ONSITE SEWAGE DISPOSAL SYSTEM

PROPERTY ADDRESS: 11755 Bragdon Wood Drive

RE: 11755 Bragdonwood
BAT Plan

SITE PLAN FOR B.A.T. INSTALLATION
A-544517
 11755 BRAGDON WOOD
 BALAKIRSKY PROPERTY, LOT 1
 SHEET 1 OF 2
 TITLE DEED: 14885/154
 TAX MAP 29, GRID 14, PARCEL 42
 5TH ELECTION DISTRICT, HOWARD COUNTY, MD.
 SCALE: 1" = 40' DATE: 10/10/2014

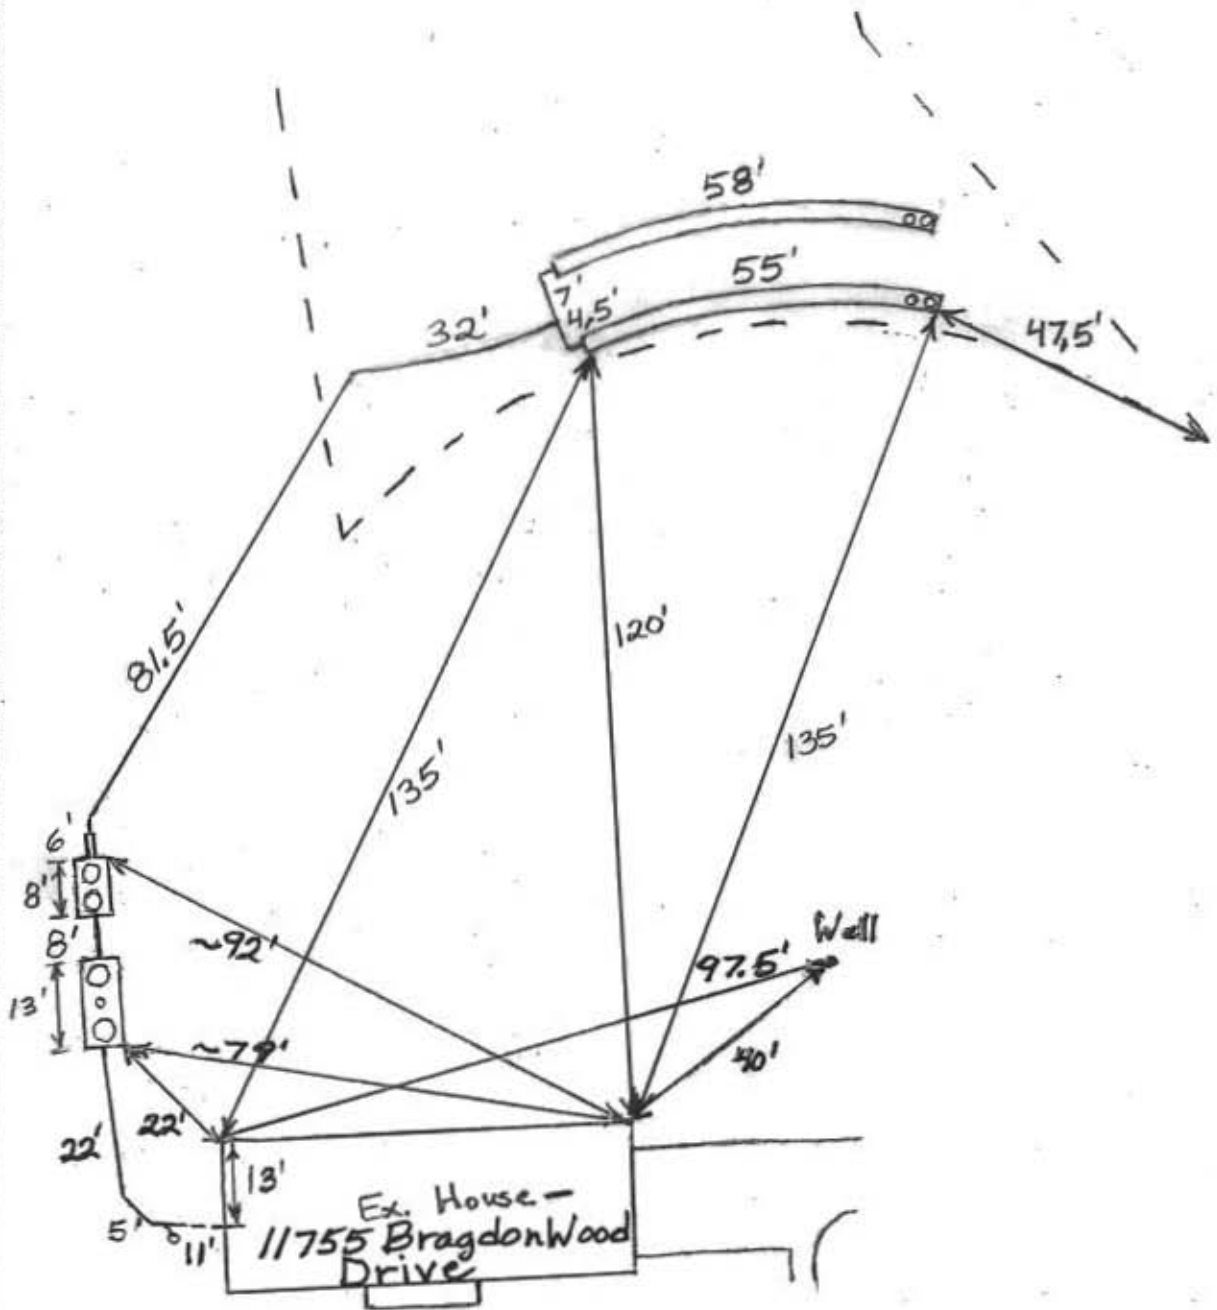
12/19/14 Tanks were set prior to my arrival. Layout not given. SEA staked per plan. Told contractor that both laterals must be staked per plan. Call when staked so layout can be confirmed. Due to office closing, contractor OK to install trenches. Final inspection includes pla test to be scheduled (yes)

12/22/2014 Cannot install trenches as staked because very large tree is in the way. Contour is terrible/unlevel. To install trenches on top of opposite side of easement. Force main installed. (B)

12/23/2014 Laterals tested before covering. Around 2.5' of head in top turn-up. Need to do final pump and alarm test. Need Ecopod certification from Babylon inspector. (B)

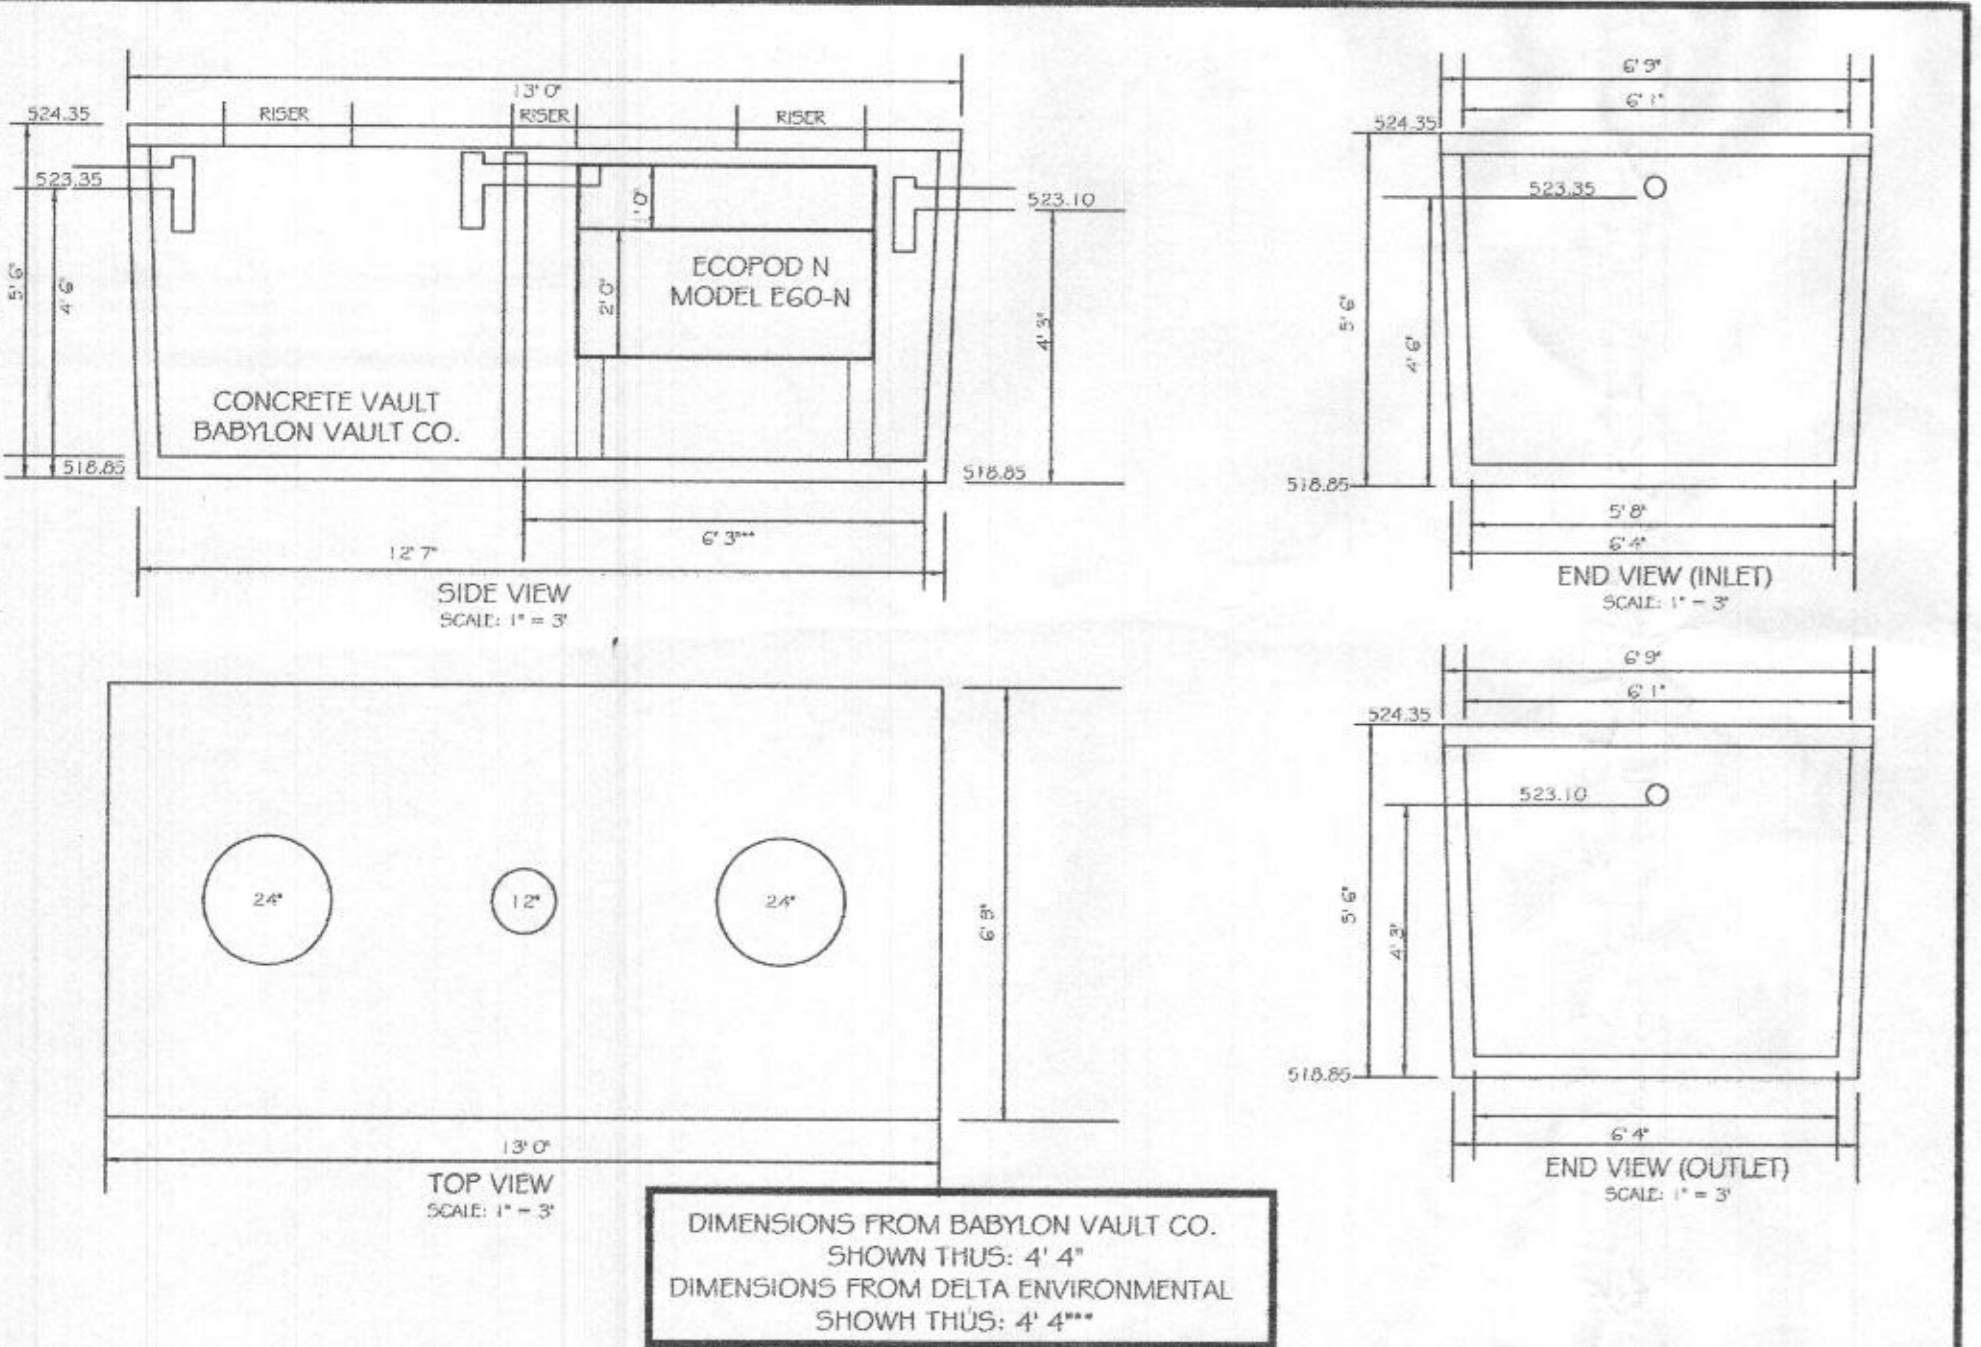
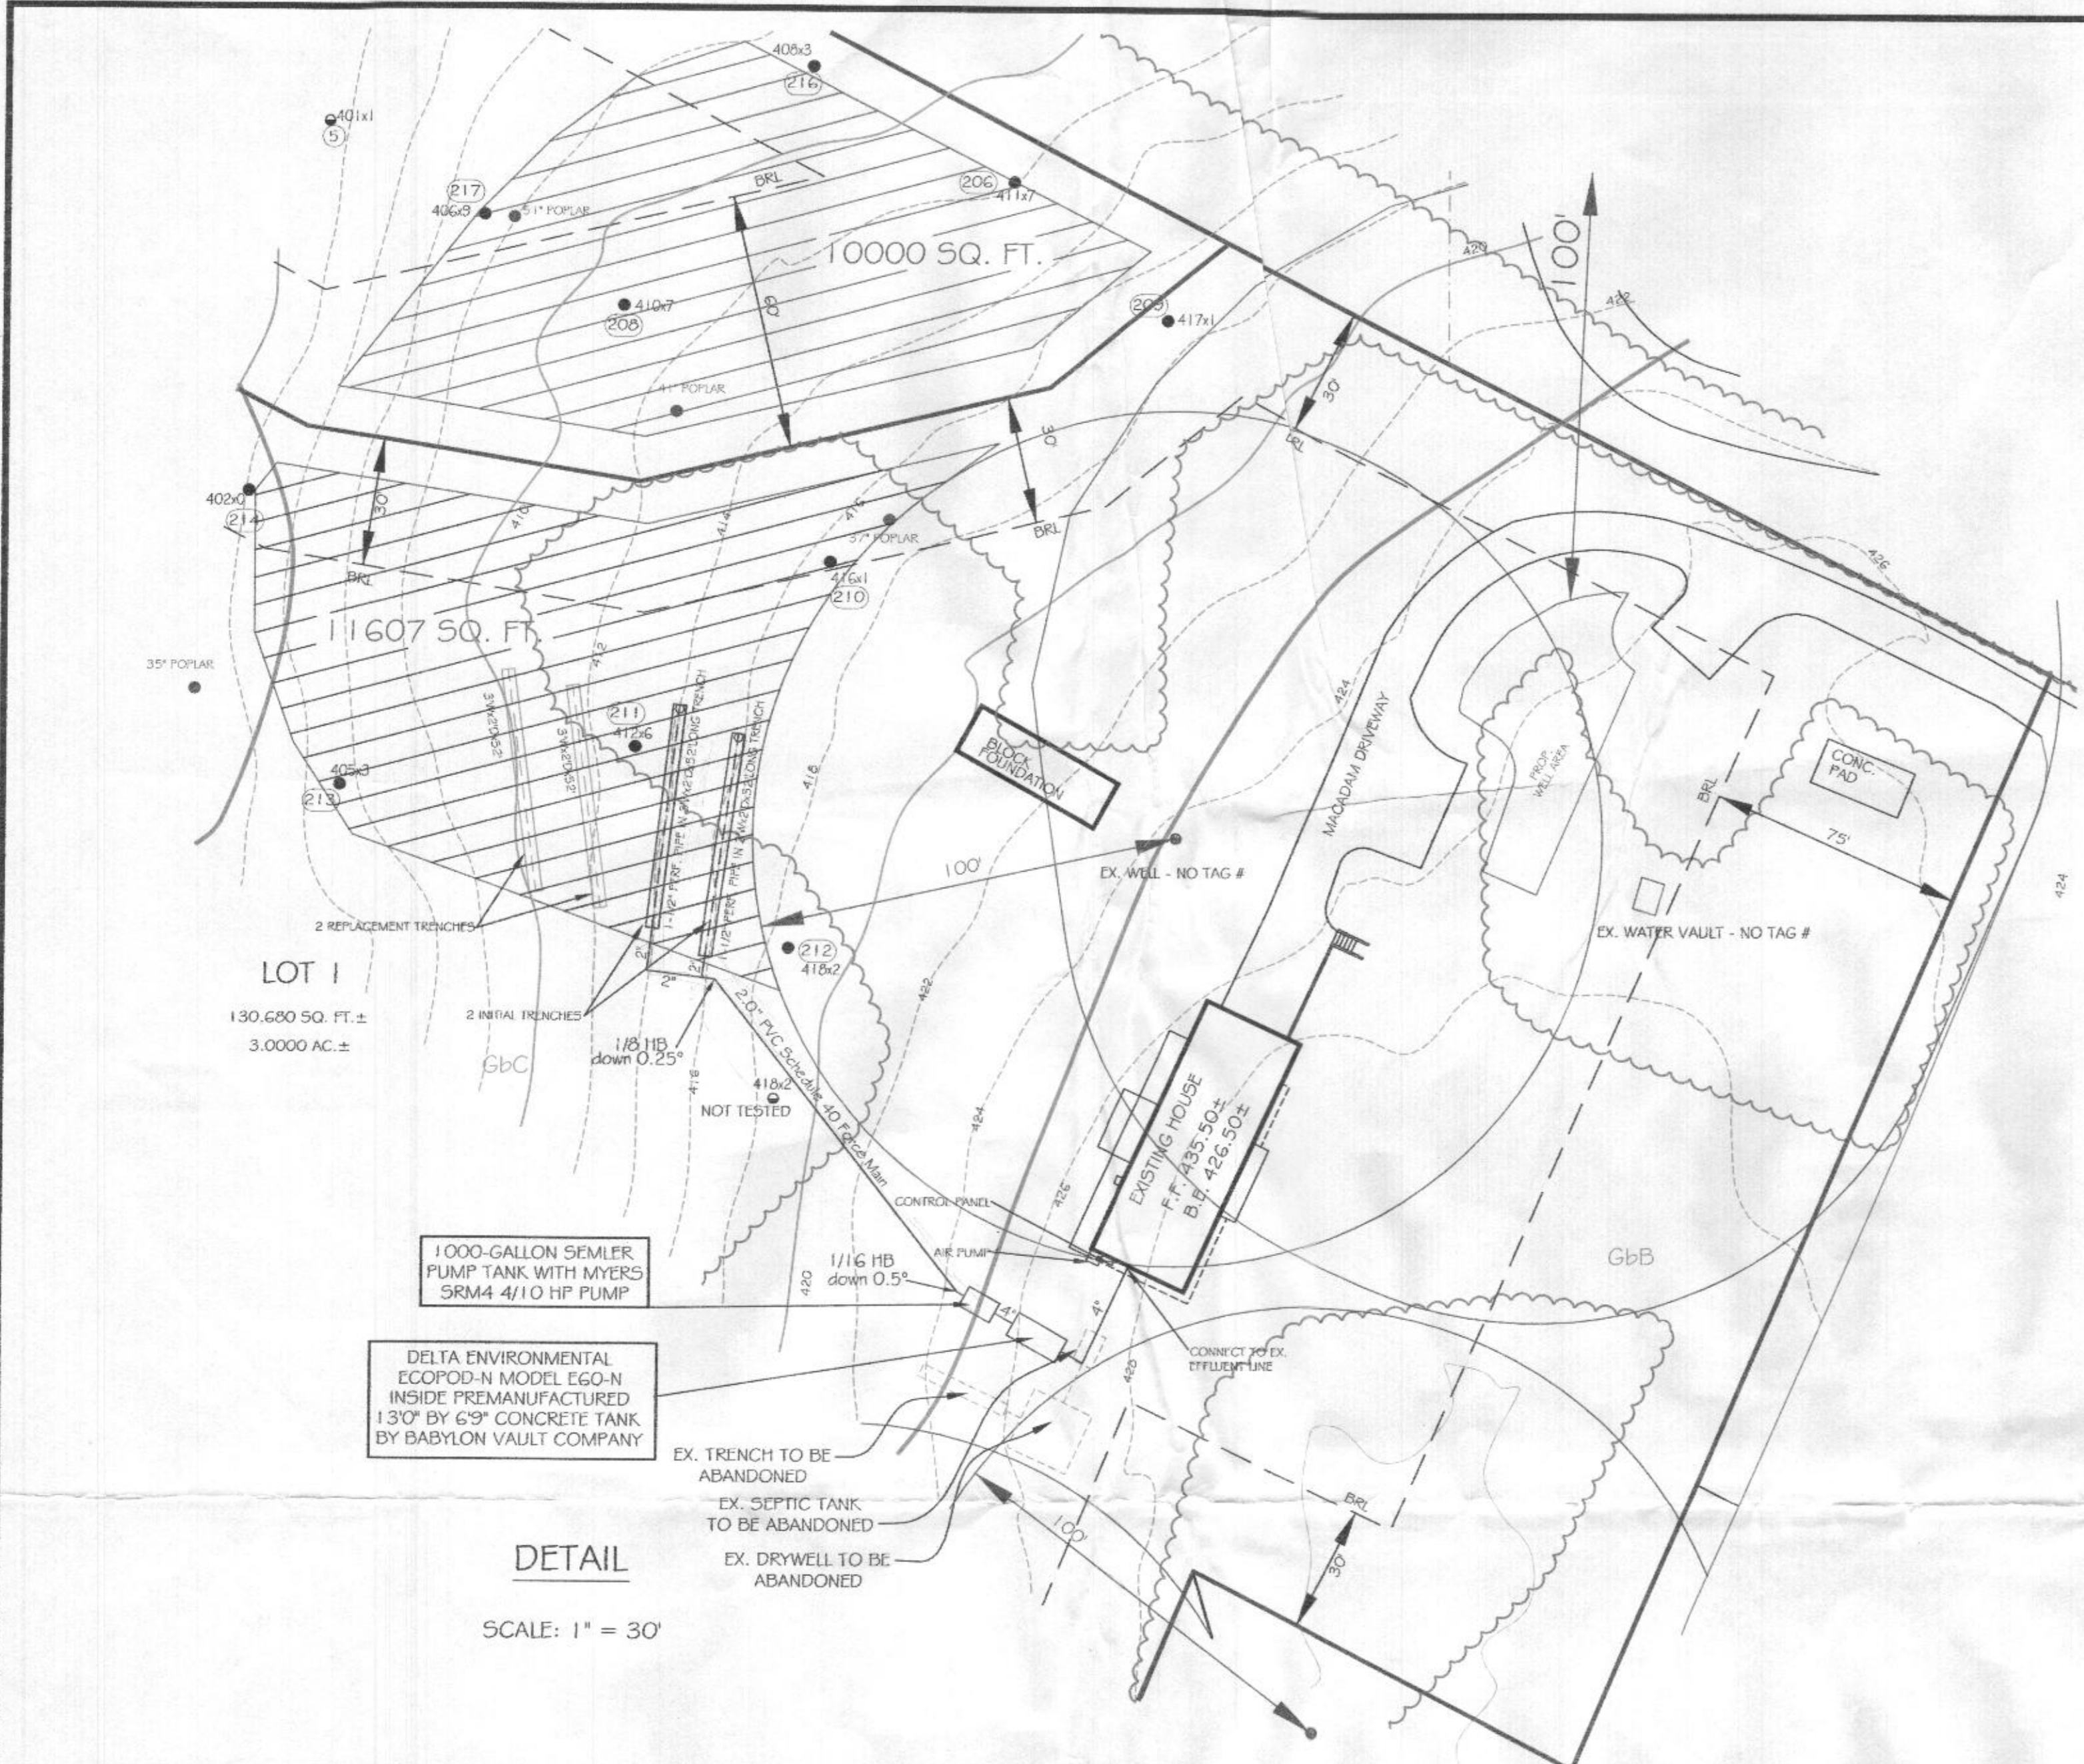
- ✦ Include the locations of all BAT components on the site plan. If you are proposing to use the Eco-pod BAT unit, all components must be shown on plan. Blower is not shown. *SHOWN ON BOTH SHEETS*

- ✦ Show the location of the initial absorption system and a replacement with perforated pipe elevations. *✓ SHOWN ON BOTH SHEETS*
- ✦ Trenches must be of equal length. Trench calculations must be shown on plan. *SHEET 1*

- ✦ BAT notes must be included. *✓ SHEET 1*
- ✦ Include a profile drawing with all invert elevations necessary for installation. *✓ SHEET 2*
- ✦ If you are proposing to use the Eco-pod BAT unit, all components must be shown on plan. Blower is not shown. *✓ SHOWN ON BOTH SHEETS*

- ✦ Existing septic easement must show trench and tank to be abandoned. *COMPONENTS SHOWN ON BOTH SHEETS*
- ✦ The existing well and the proposed well symbols must be shown in the legend. *SHEET 1*
